# Montgomery County Planning Board

MCPB No. 22-042  
Site Plan No. 820220010  
12710 Twinbrook Parkway  
Date of Hearing: April 7, 2022

## CORRECTED RESOLUTION

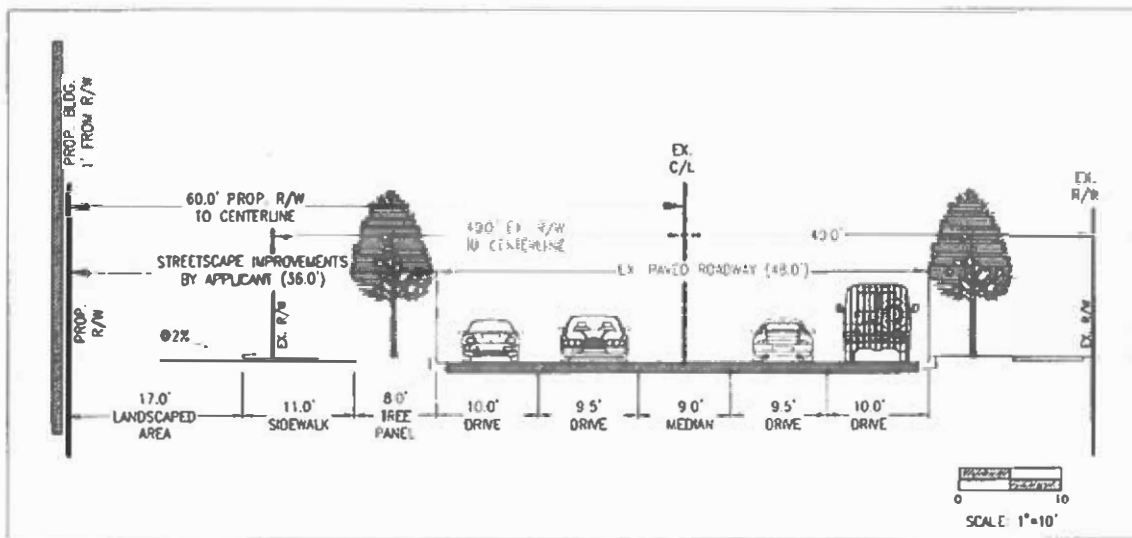
Consistent with approaches undertaken for similar projects with frontage improvements established by the *Bicycle Master Plan*, such as the neighboring approved Site Plan for 12500 Ardennes Avenue (820200080), Staff worked with the Applicant to provide an interim design solution along the roadway frontage prior to formal implementation of the planned bicycle facility. Along the Twinbrook Parkway frontage, the Applicant proposes to construct a 17-foot wide landscape and patio area, a wider sidewalk, measuring 11 feet in width, with an eight-foot tree panel, consistent with guidance within the *Twinbrook Sector Plan Design Guidelines* and the *Complete Streets Design Guide*. In the future, the 17-foot wide landscape and patio area and 11-foot wide sidewalk will be converted to a separated bikeway and sidewalk as part of the future implementation of the Twinbrook Parkway bikeway improvements. As proposed, the Project provides adequate right-of-way dedication<sup>4</sup> for the future bikeway and does not preclude its future installation.

As an interim use, the Applicant proposes the 17-foot wide landscape and patio area of the Twinbrook Parkway frontage for café seating. Additional hardscape and vegetated areas will be placed to the rear of the proposed sidewalk to provide an active streetscape and comfort from vehicles traveling along the Arterial. The provision of additional seating accessible to the public realm and

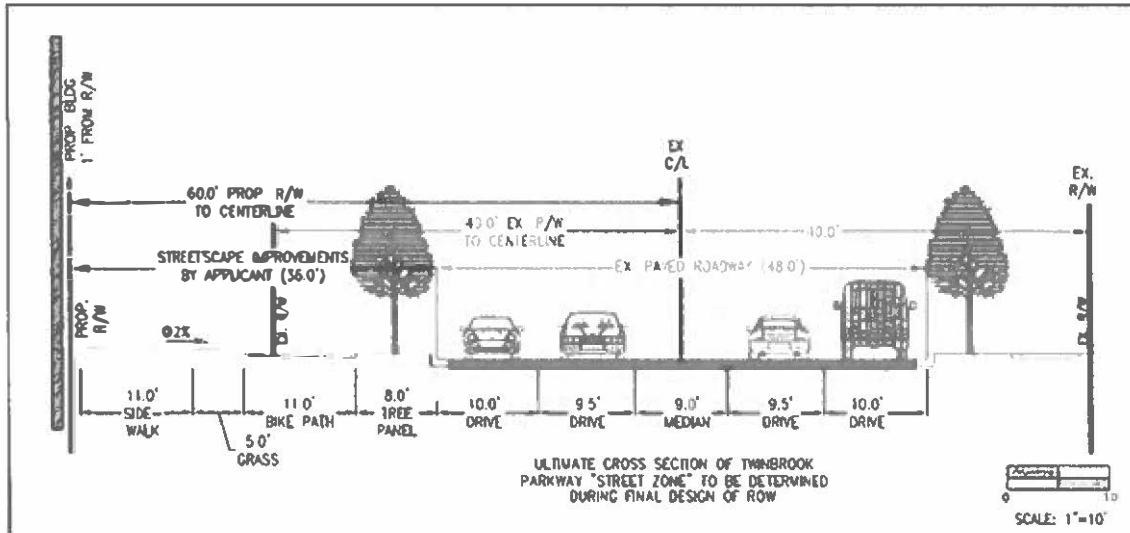
The segment of Twinbrook Parkway along the Property frontage is classified as A-37, an Arterial, within the *Master Plan of Highways and Transitways*. Per the existing plat number 9812, the segment currently has a width of 80-feet, short of the planned 120-foot-wide requirement, despite meeting the planned four (4) divided travel lane configuration. The Applicant will provide a public right-of-way dedication of 20-feet to meet the required 60-foot distance from the roadway centerline.

As illustrated below, the full build out of the bikeway and sidewalk would repurpose space temporarily occupied by café seating and landscaping for the provision of two-way separated bicycle lanes, the sidewalk, pedestrian buffer, and street buffer.
